PLANNING, ZONING, & BUILDING DEPARTMENT
PZ&B Staff Combination Memorandum: Architectural Commission and Town Council

SUBJECT: ARC-24-008 (ZON-24-047) 264 DUNBAR RD (COMBO)

MEETING: APRIL 24, 2024
MAY 15, 2024

Currently Proposed North Elevation

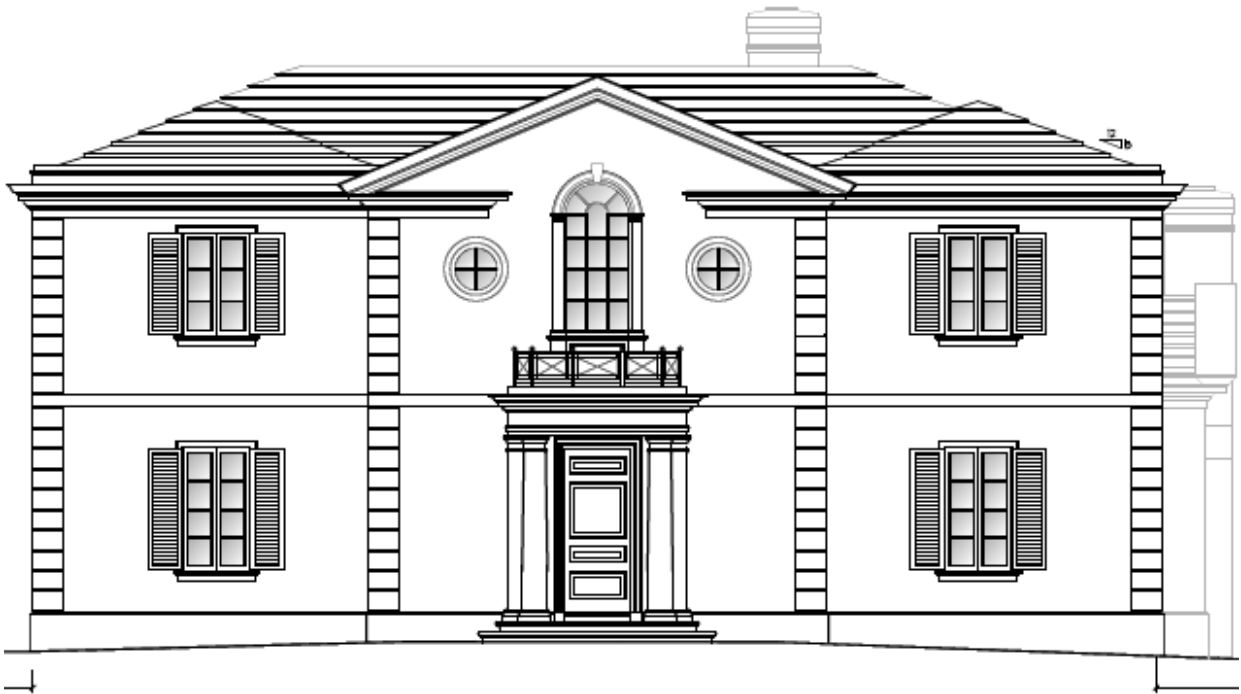
The applicant has resubmitted plans in response to comments of the architectural commission. The front façade was adjusted by extending the entry and open pediment, incorporating two round windows and a singular arched window on center. The string course was simplified and the parapets in the pediment were eliminated. The balcony detail was also simplified. Adjustments to the hardscape and landscape include modification of driveway paving along the west garden by reducing the overall width of the paving to accommodate additional paving at courtyard garden. The courtyard fountain area has been revised in response to ARCOM comments, lawn was removed and paving and plantings were added.
